TSB-315

Extra Heavy Duty Slave Cylinder

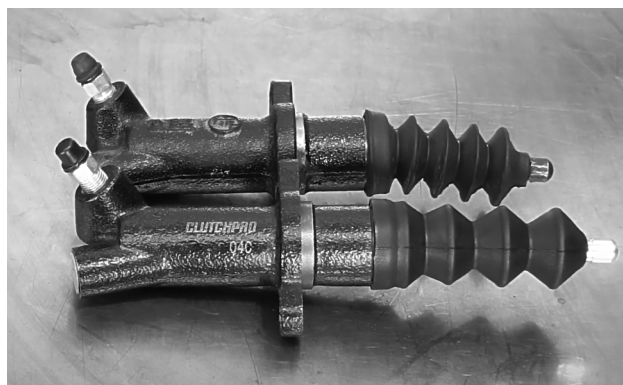
Please note the slave cylinder provided in this kit must be used to replace the original unit.

The new slave cylinder has a smaller piston compared to the original unit, which helps to change the friction point of the clutch pedal to a more comfortable position.

Failure to install the new slave cylinder supplied in this kit can cause the friction point to be very close to the floor and may even result in difficulty selecting gears.
